BOULDER COUNTY PLANNING COMMISSION PUBLIC HEARING

STAFF RECOMMENDATION

Docket SU-20-0003: Jubilee Acres Reception Hall

Proposal: Special Use and Site Specific Development Plan request for a reception hall to host weddings and other events approximately 150 times per year on a 36-acre parcel.

INTERIM EROSION CONTROL

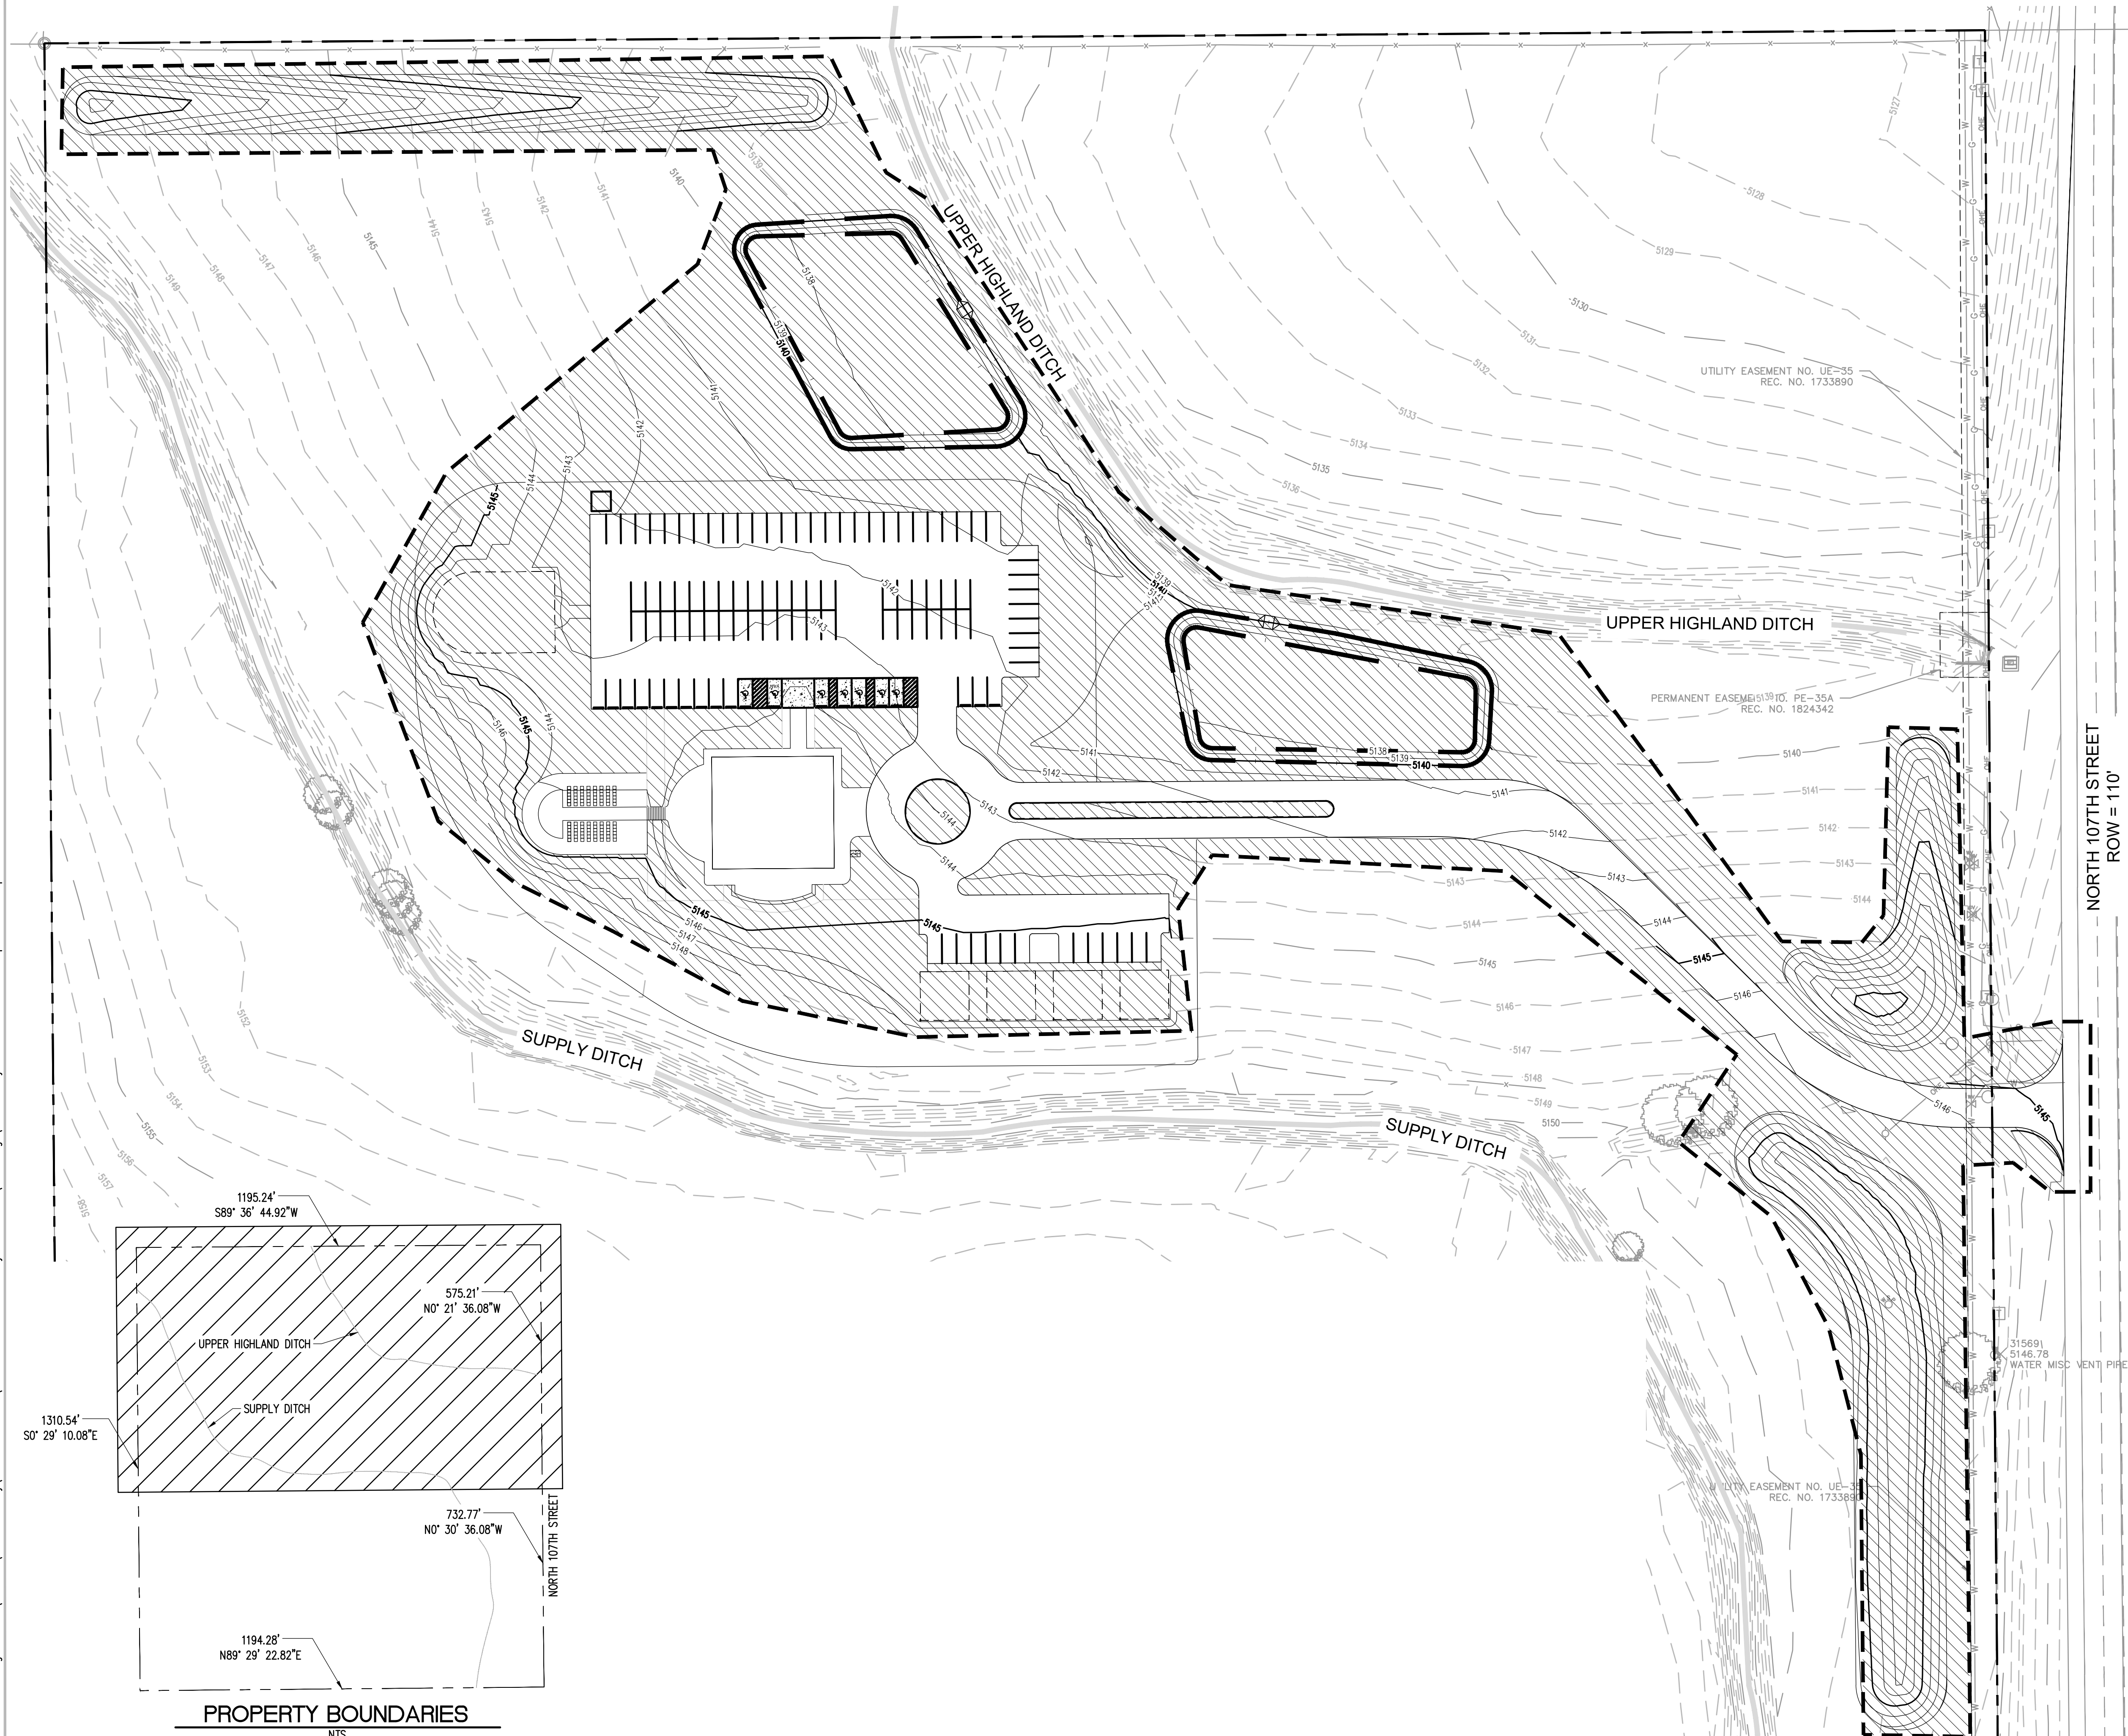
What is the total disturbance acreage, including future chapel, cabins, all parking, and grading for septic, landscaping, stormwater infrastructure, roads and circulation (from drawing ER-1.1 it appears to be about 9 acres)?

What is the total disturbance acreage, including future chapel, cabins, all parking, and grading for septic, landscaping, roads and circulation? Drawing ER-1.1 shows this to be 9.1 acres. If correct, this translates to 25 percent of the entire 36-acre parcel that would be, at least, disturbed for construction. From a parcel perspective, this would be a significant negative impact.

LANDSCAPE
PLAN

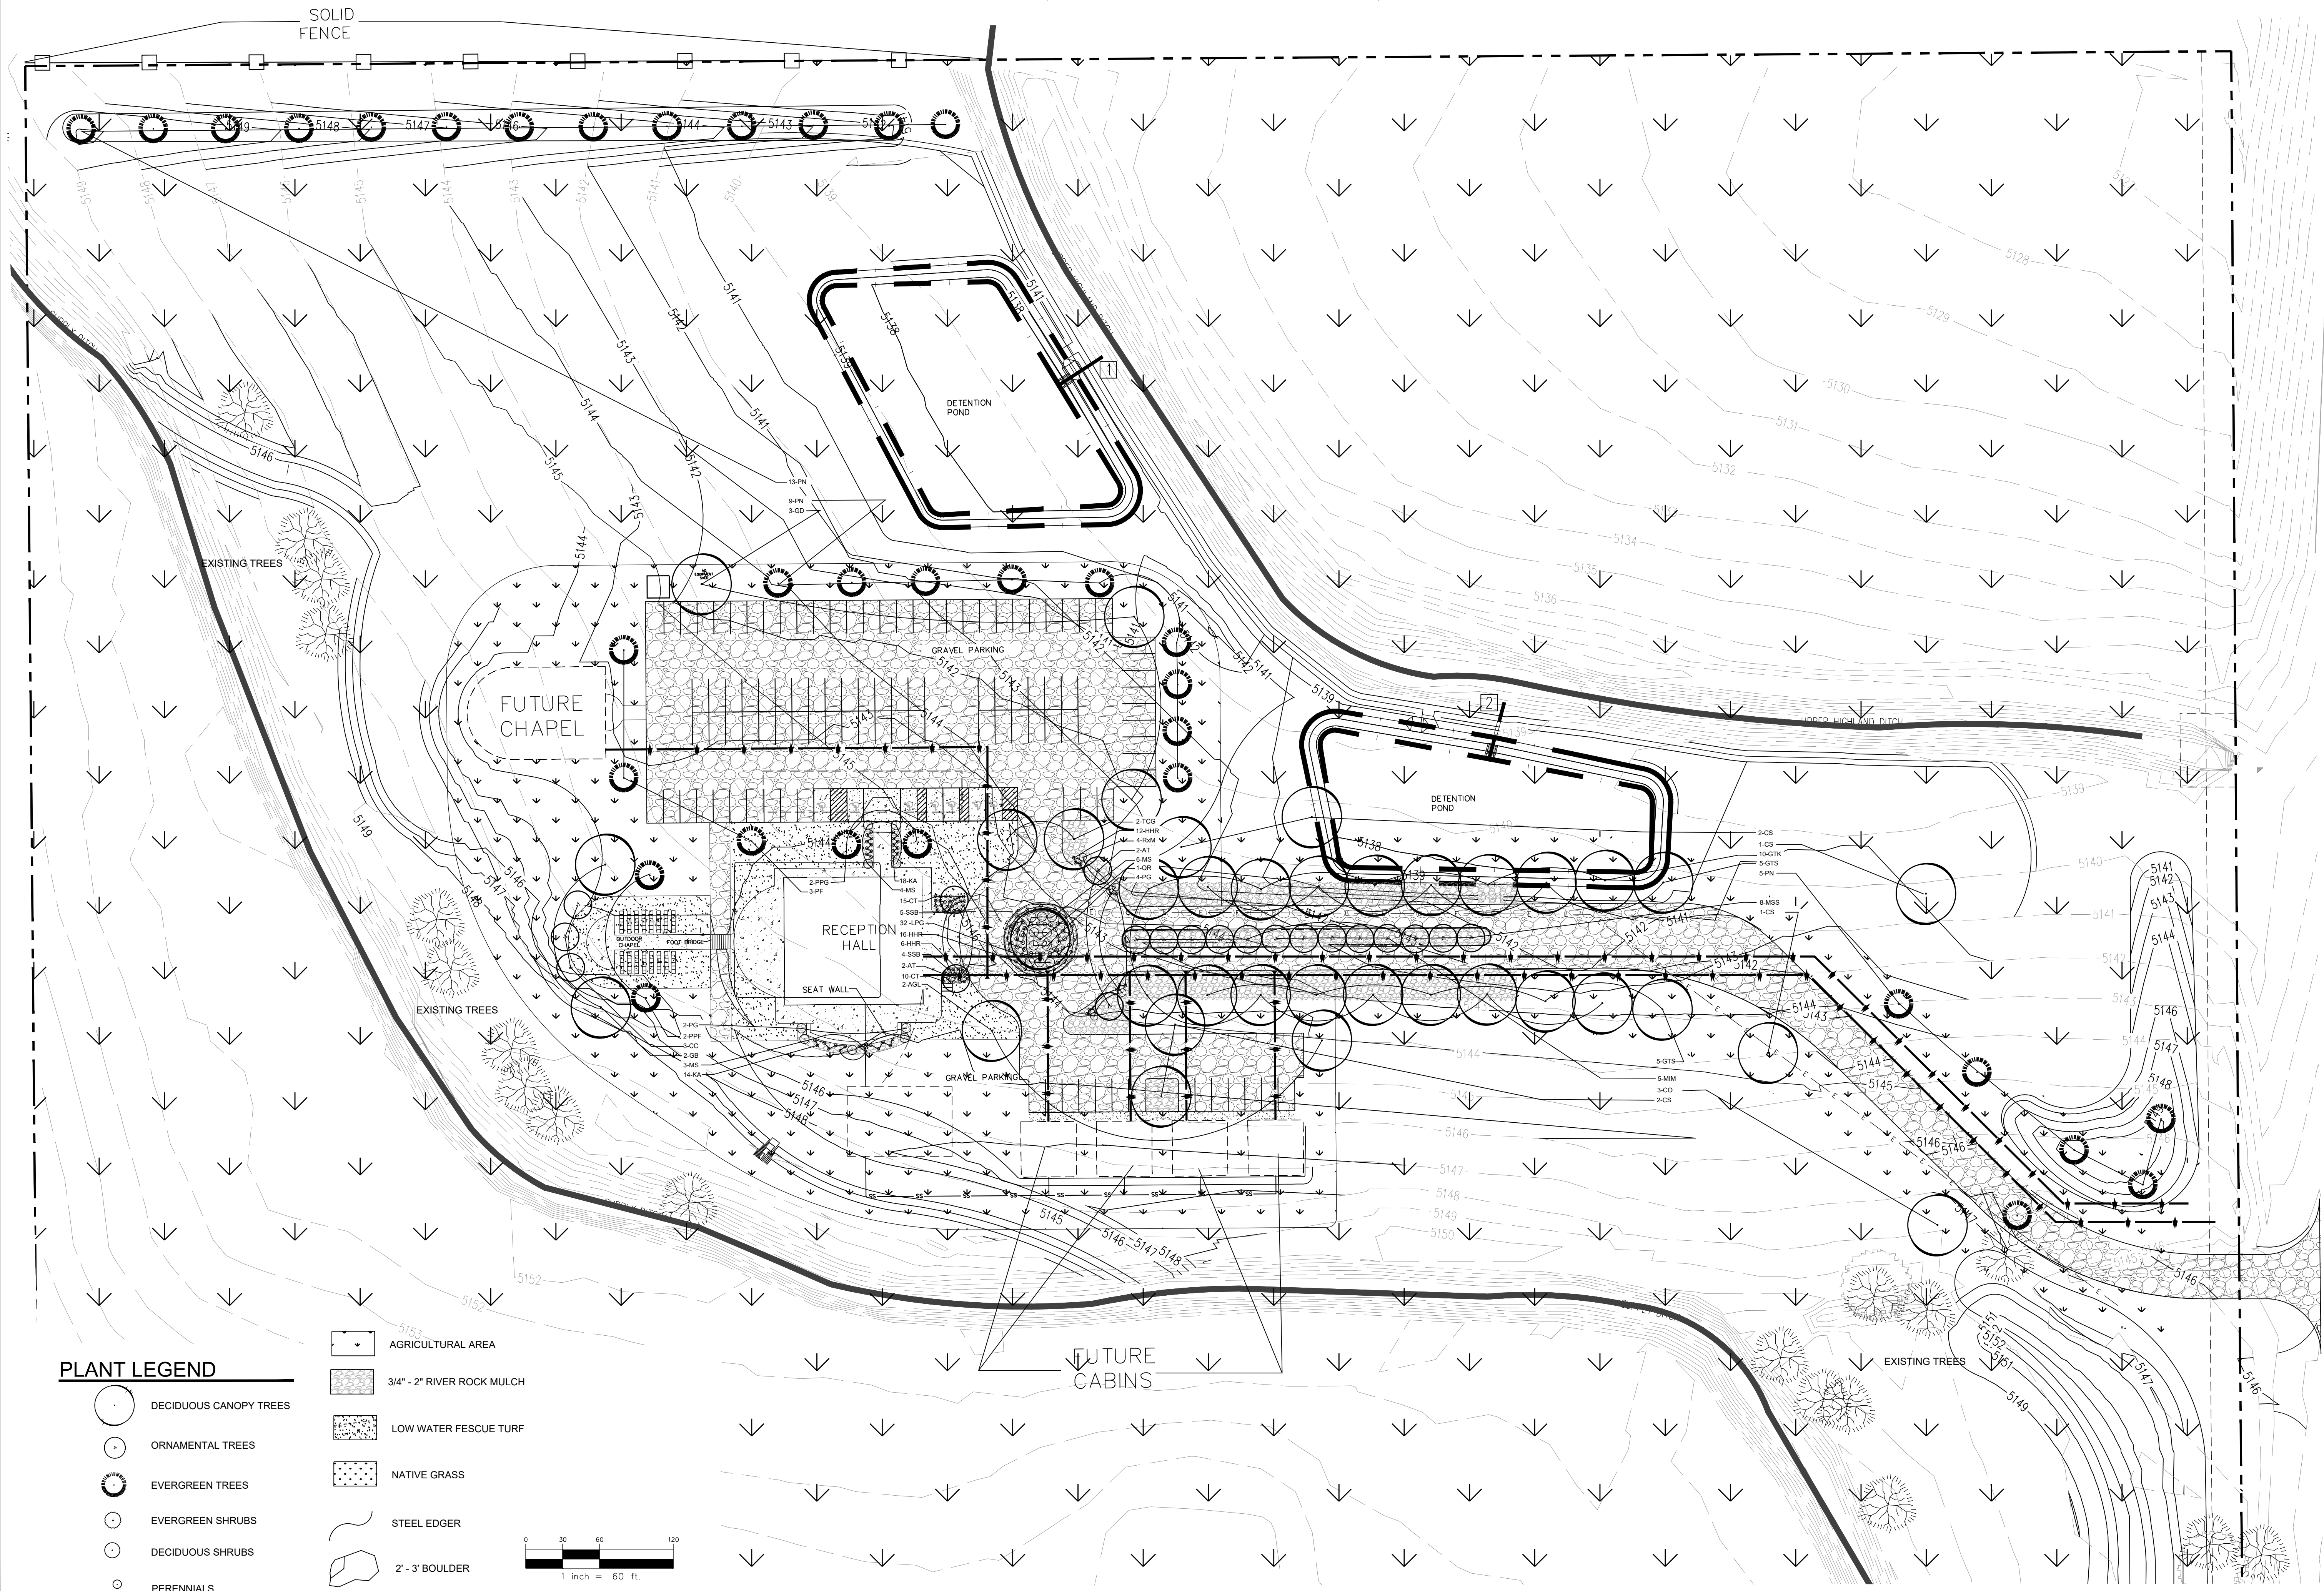
LS-1.0 – This drawing shows that the surfaces of the two retention ponds are to receive native grass seed. How would this vegetation in the ponds be managed, to keep them from becoming simply dusty basins?
